From:	Joseph Massey
To:	Jae Lim
Cc:	Kevin Moscatiello: Edwards, Gary: Darryl White
Subject:	RE: SES-LIC-20201117-01252; Call Sign: E202189
Date:	Tuesday, March 9, 2021 1:45:40 PM
Attachments:	image002.png
	image003.png
	image004.png
	image005.png
	image006.png
	image007.png
	image008.png
	image009.png

Denali hereby requests the following changes/corrections to the subject application referenced below:

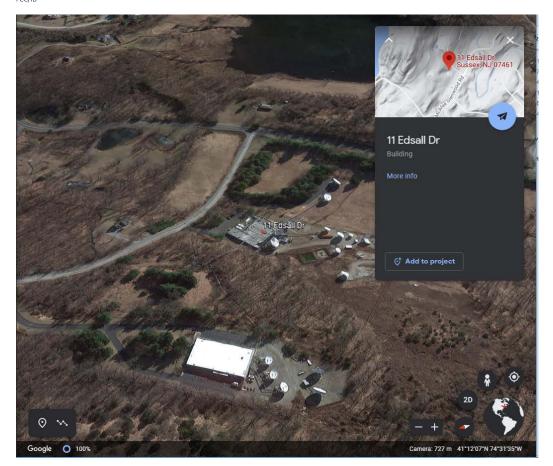
- 1. The site coordinates should be Lat: 41 12 07 N Lon: 74 31 35 W (WGS84) and zip code should be 07461 (Sussex, NJ).
- 2. Eliminate the 1M00G7W emission between 13772 MHz and 13778 MHz and replace with
- 6M00G7W in this band at 71 dBW/6 MHz or 39.23 dBw/4 kHz.
- Correct EIRP density for the 36M0G7W emission between 14000 and 14500 MHz to 45.4 dBw/4 kHz.

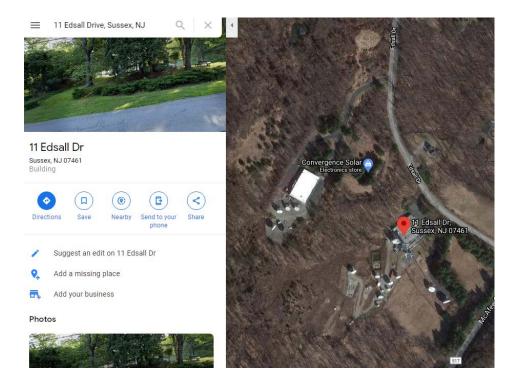
We looked for your antenna at coordinates you provided and are not able to find the antenna.

We are thinking the site address and coordinates don't match. Please confirm the site address, zip code, and coordinates. Please let us know location of your antenna in Google earth.

Freq bands 13.75-14 GHz needs NTIA coordination according to US357: Please verify frequencies in green and red are correct for NTIA coordination.

The address for this location should be : 11 Edsall Drive, Sussex, NJ, 07461. See attached photo. The site coordinates shown below are correct at red mark out. The specific antenna is marked in blue on the left side of the photo. Disregard the Convergence Solar mark out. That does not exist on USEI's property.
